AMS02-TCS

Doc.Nº: NCR-TCS-CGS-C-006

NON CONFORMANCE REPORT

RAM RADIATOR Heaters

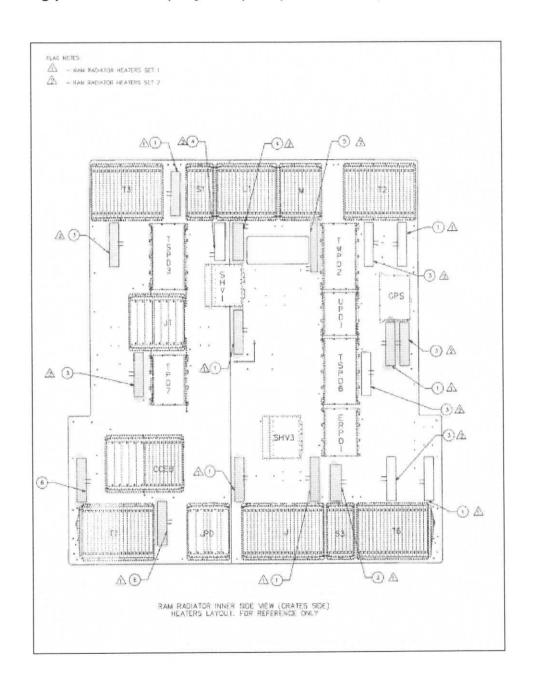
The following picture shows (in yellow) the patches that present unusual defects:

The heaters that present unusual defects are listed in the following table together with the defect type and picture reference if any.

Heater#4-4

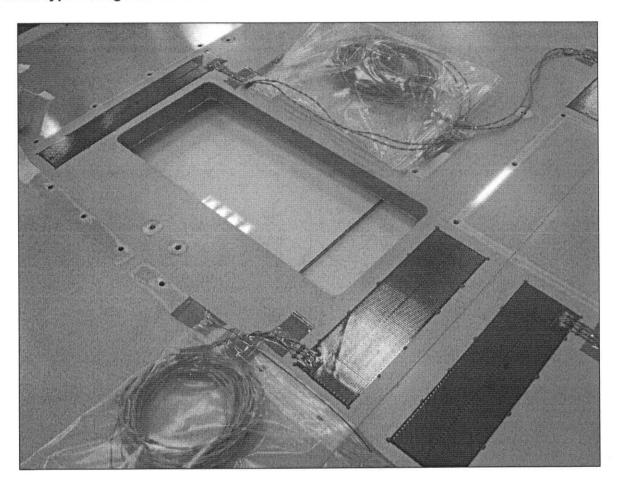
Defect type : diagonal wrinkle

Heater#17-2

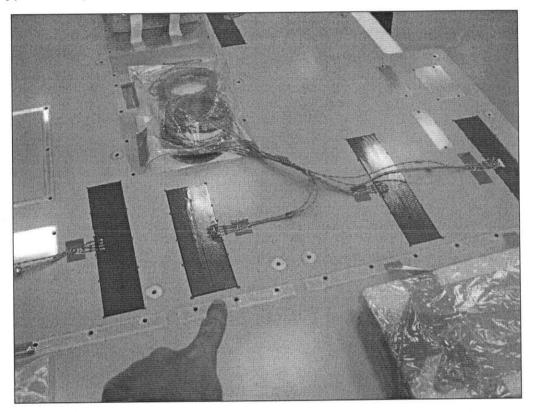
Defect type: straight long bubble

Heater#15-1

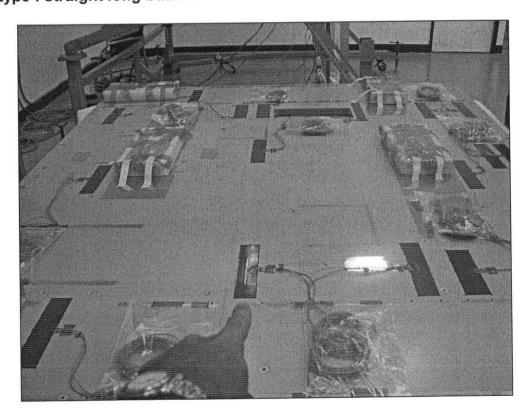
Defect type: straight long bubble

Heater#5-5

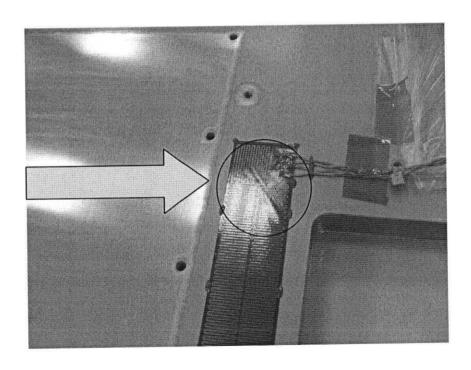
Defect type : diagonal wrinkle
